7 June 2022

**27A-29 PINE AVENUE, BROOKVALE
ADDENDUM - STATEMENT OF ENVIRONMENTAL EFFECTS
DA DA2021/2153 - Proposed demolition and redevelopment of the site for a
residential flat building; Appeal 2022/00014963**

Figure A - The amended proposal provides two, 10.35m gaps at the upper level within the length of the proposal development which increases solar access

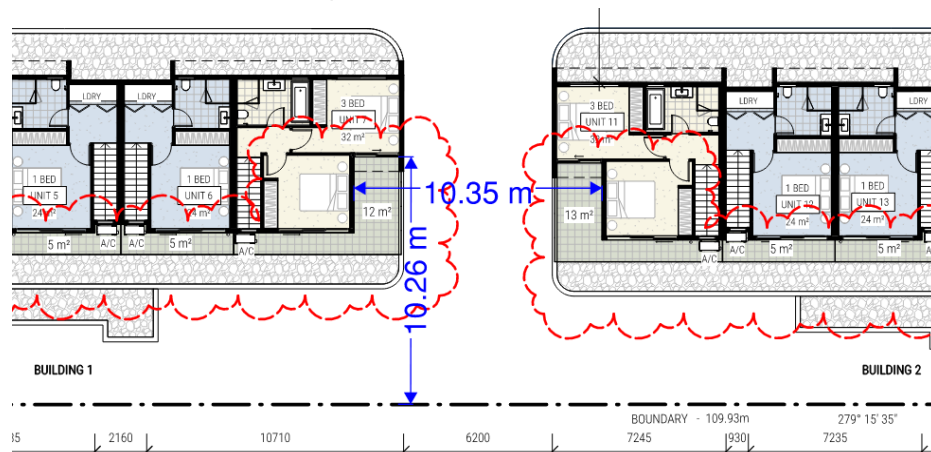
- Reduction in bedroom areas in units 7, 11, 15, 19. The bedroom areas have been reduced to the minimum size under the ADG to improve the solar access to the southern neighbour. The reduction in these areas results in increased southern side setbacks to proposed units 7 and 11 (first building break) and proposed units 15 and 19 (second building break) (figures A and 7 to 10 illustrate) and allows for additional sun to various apartments at different times; the impacts can be seen on the Views from the Sun diagrams. These areas

Figure 6 – amended 1st floor level plan

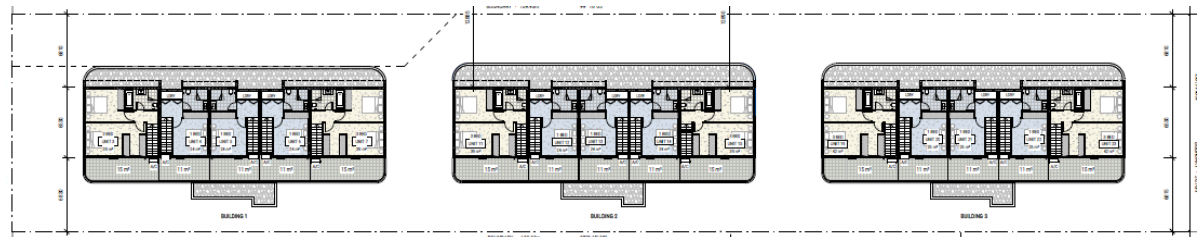
- Level 1 - opposing units 7 / 11 and 15 / 19: frosted glazing to the kitchen windows, privacy screens to the north facing balconies.
- Level 2 - southern balconies are reduced in size with an increased southern side setback of approx. 5.9m from approx. 4.6m previous. The balconies provide a southern distant outlook, but are inset from the building edge to limit downward looking to neighbours at 23B-27 Pine Ave. The small balconies allow for improved outlook light and ventilation to the bedrooms without inappropriate privacy impacts.

Figure 10 – amended roof plan

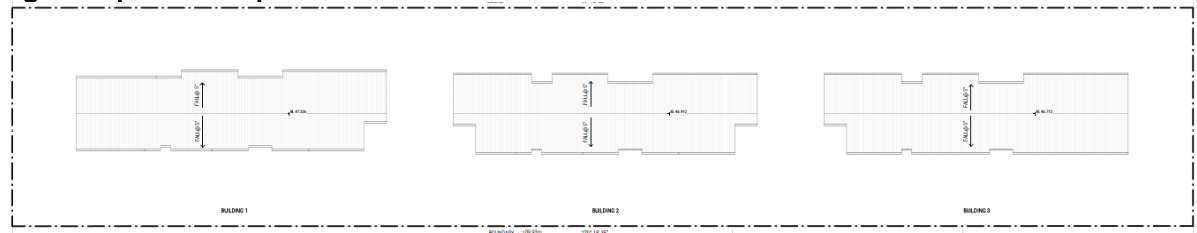
- The roofs of each of the three proposed buildings have been lowered so that all top floor apartments have 2.4m ceiling heights, as allowed under Objective 4C-1 of the ADG for two storey units with less than 50% of the area on the upper floor. These height reductions have improved sunlight access to the neighbouring building to the south.

Figure 12 – amended design facade perspective

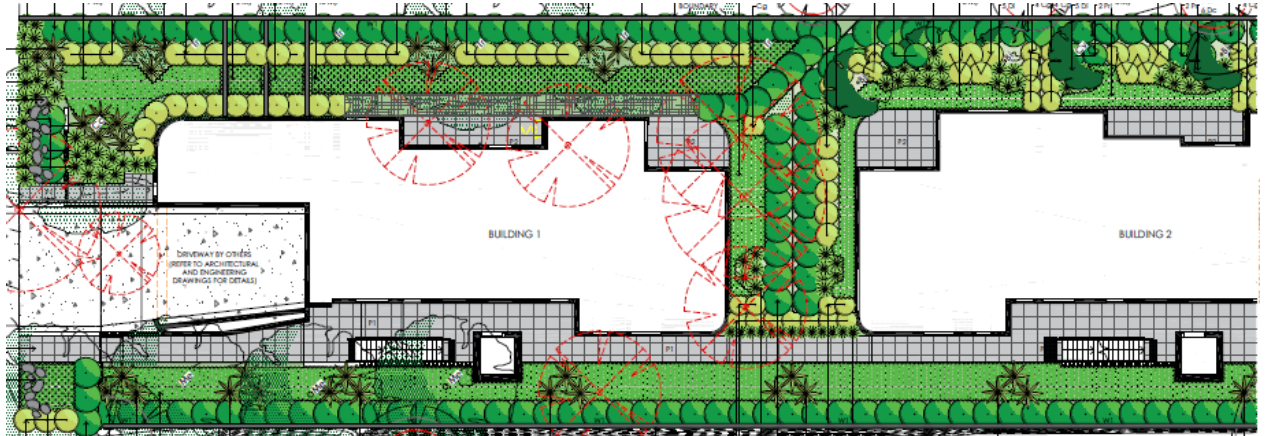
The western (front) building façade has been altered (figures 11 and 12).

The front façade has been amended to clearly address the street rather than side boundaries. Additional windows have also been added to this façade which assists in casual observation of the street.

The amendments provide improved materials, improved delineation of the upper storey, enhanced streetscape presentation of the building, and overall, a compatible development outcome when viewed from adjoining land and the streetscape.

The pedestrian entry on the southern side of the property frontage has been altered to include a roofed portico, letterboxes, and landscaping. These have enhanced the legibility and functionality of the pedestrian entry.

Figure 14 – amended landscape plan – front half

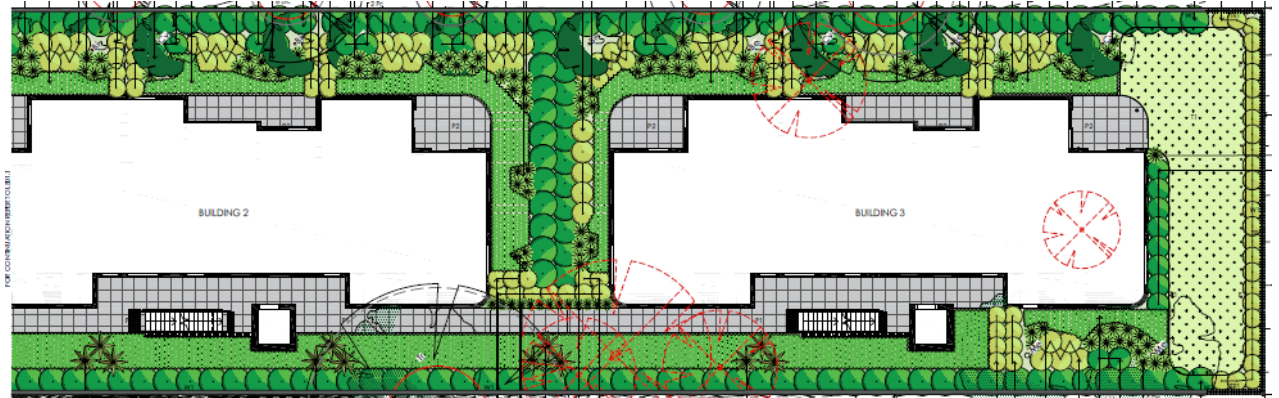
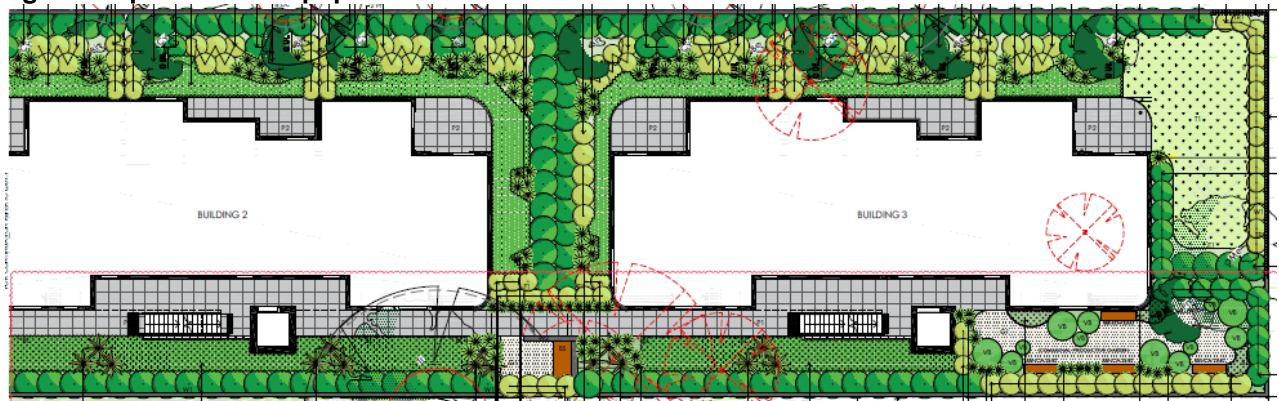
- Fencing between residences has been included on the amended landscape plans and noted as 1800mm high fencing. The fencing will provide privacy between dwellings at ground level as well as containment for pet owners.

A calculation of communal open space area is provided at sheet DA400 of the architectural plans. It demonstrates that 476m² and 21% of the site area is provided. The landscape plans have been amended to include these spaces.
